## S E R V I C E N O T E

**3235A Switch/Test Unit****Serial Numbers:** 2843A00000 / 2843A03110**Incorrectly Labeled Line Voltage Switches May Cause Switch Setting Confusion****Situation:**

**Figure 1. AC Line Voltage Switch Positions****Solution/Action:**

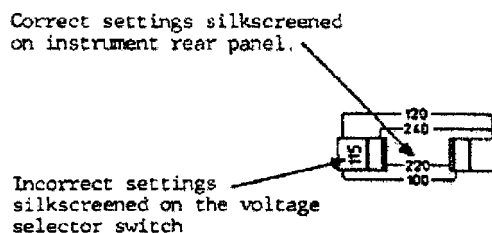
Some units may have incorrectly labeled line voltage selection switches installed. The correct settings appear silkscreened on the instrument rear panel. The incorrect settings are silkscreened on the voltage selection switches themselves.

No action is required. However, to avoid confusion, the incorrectly silkscreened line voltages may be easily scratched off using a flat-head screwdriver.
